QUALITY ASSURANCE -- NON-CONFORMANCE REPORT

Location: Changxing Island, Shanghai, P.R. China **Report No:** NCR-000747
Prime Contractor: American Bridge/Fluor Enterprises, a JV **Date:** 27-May-2010
Submitting Contractor: Zhenhua Port Machinery Company, Ltd (ZPMC), Changxing Island **NCR #:** ZPMC-0710

Reference Description: West Shaft: The Bearing Stiffeners overlap on the anchor bolt holes at External Skin D.

SAN FRANCISCO OAKLAND BAY BRIDGE
 EAST SPAN SEISMIC SAFETY PROJECT
 SELF-ANCHORED SUSPENSION BRIDGE
 (SUPERSTRUCTURE & TOWER)

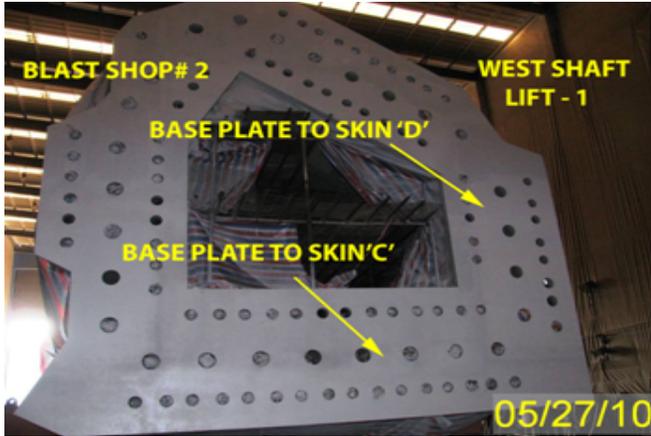
During the Quality Assurance Inspection of Anchor Bolt Hole to Bearing stiffener distance measurement at West shaft Skin D External side, this Quality Assurance Inspector discovered the following issue:

- Type 2 Bearing stiffeners are overlapping on top of anchor bolt hole.
- Type 2 Bearing stiffeners to Anchor bolt hole distances at five (5) different locations found approximately -2 mm, -2mm, -3mm, -4mm, -4mm.
- The Anchor bolt holes found inappropriate readings are consecutive from Skin 'D' side. (For readings see above)
- This bearing stiffener is found in Skin D of External West Shaft Lift 1.
- The location is Skin D, near CD Corner.

Reference Resolution: Attached is the contract drawing showing that the holes are oversized and the conflicts of 4mm, 3mm, and 2mm is not an issue because of the large oversized holes.

Although the bearing stiffeners were not built to contract tolerances, there is enough flexibility in the design to account for the potential conflict during installation of the anchor rods. This NCR is conderised accepted with action pending and will be closed once final installation of the anchor rods has been achieved in Oakland without conflict.

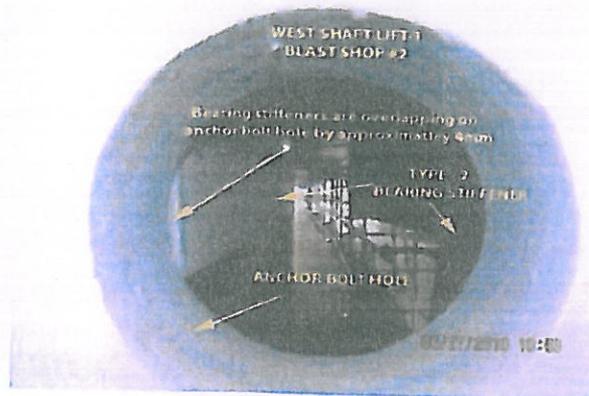
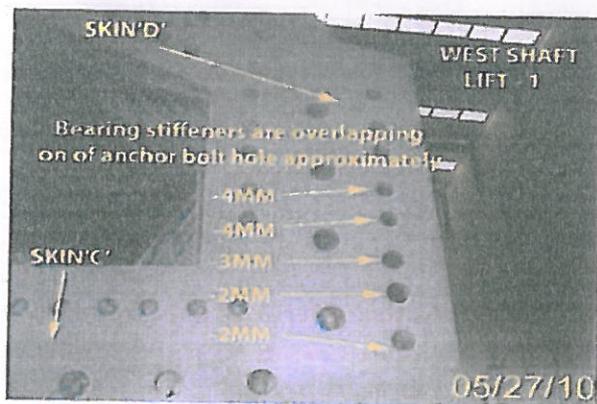
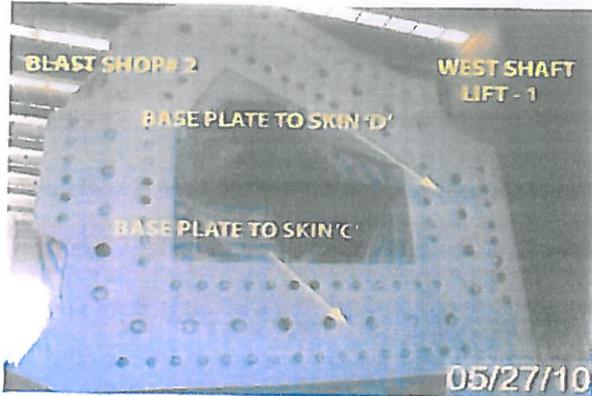
During the Quality Assurance Inspection of Anchor Bolt Hole to Bearing stiffener distance measurement at West shaft Skin D External side, this Quality Assurance Inspector discovered the following issue:

- Type 2 Bearing stiffeners are overlapping on top of anchor bolt hole.
- Type 2 Bearing stiffeners to Anchor bolt hole distances at five (5) different locations found approximately -2 mm, -2mm, -3mm, -4mm, -4mm.
- The Anchor bolt holes found inappropriate readings are consecutive from Skin 'D' side. (For readings see above)
- This bearing stiffener is found in Skin D of External West Shaft Lift 1.
- The location is Skin D, near CD Corner.

Contractor to assess the impact of the mis-alignments of the anchor bolts on the erection, proposes to leave as-built if no interference to site erection. The issue will be re-addressed in Oakland and the NCR will only be closed subject to the successful erection, corrective action to be taken by ABF otherwise.

Construction/Design confirmed the mis-alignment appear to have no impact on the erection as designed. No retrofit works was necessary. Erection of the base plate was completed successfully in Oakland.

TOWER ANCHORAGE DETAILS NO. 6	
DATE	12/6/04

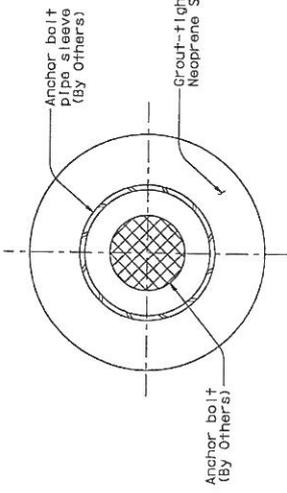
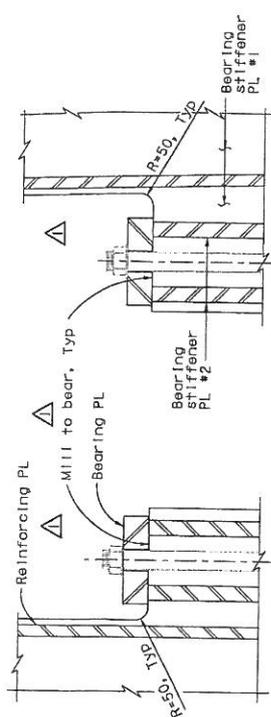
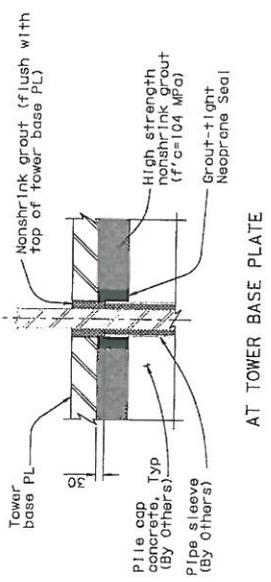
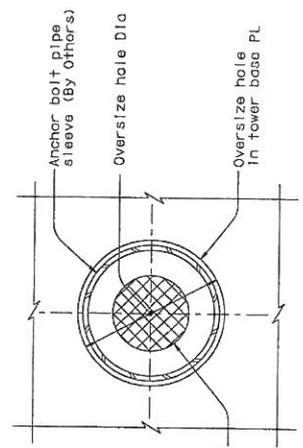
ZPMC acknowledge this issue, and it was submitted to ZPMC technician and ABF for evaluation as soon as we found at site. The further information about anchor bolt Dia and oversize hole Dia was shown on the drawing, we could find the hole Dia is 70mm bigger than the anchor bolt Dia. This means there is flexible to the installation in America in despite of the conflict by 4mm, 4mm, 3mm, 2mm and 2mm. The space is still enough to the anchor bolt.

Despite the conflicts that were noted in the NCR, the bolt holes were designed to be oversized to account for any potential issues during installation. Attached is the contract drawing showing that the holes are oversized and the conflicts of 4mm, 3mm, and 2mm is not an issue because of the large oversized holes. Based on this ZPMC requests closure of this NCR.
